Subject: Loss of Steering Assist and/or Loss of Brake Assist Malfunction Indicator Lamp (MIL) Illuminated - DTCs P25A2, U0422, C1595, U0420, C116C, B3205, B127B and/or B1325 Set

Brand:	Model:	Model Year:		VIN:		En- gine:	Transmis- sion:
		from	to	from	to		
Chevro- let	Silverado 1500 (New Model)	2019	2019				
	Silverado 1500	2020	2021				
	Silverado 1500 - LTD (RPO J21, VIN Digit 5 = W/Y)	2022	2022				
	Chevrolet Silverado 1500 - New (RPO J22, VIN Digit 5 = A)						
	Silverado 1500	2023	2023				
Sierra	Sierra 1500 (New Model)	2019	2019				
	Sierra 1500	2020	2021				
	Sierra 1500 - Limited (RPO J21, VIN Digit 5 = 8/9)	2022	2022				
	Sierra 1500 - New (RPO J22, VIN Digit 5 = H/U)						
	Sierra 1500	2023	2023

5182364

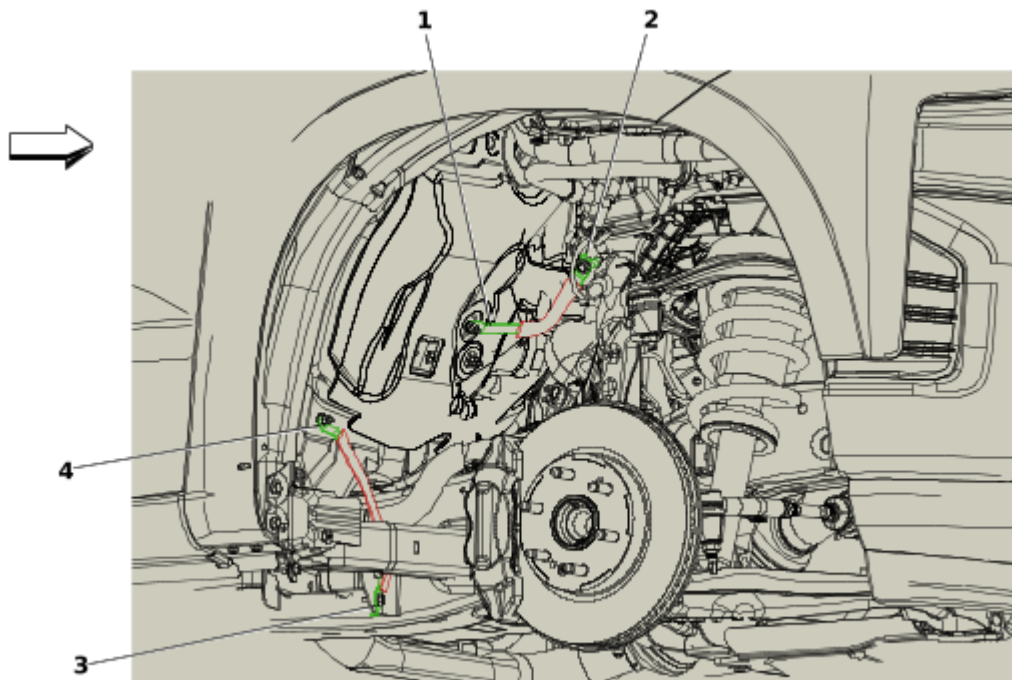
This condition may be caused by High resistance in the G132 and G133 grounds, located behind the RH wheelhouse liner.

Inspect G132 (1) and G133 (4) for high resistance and repair the ground straps as necessary.
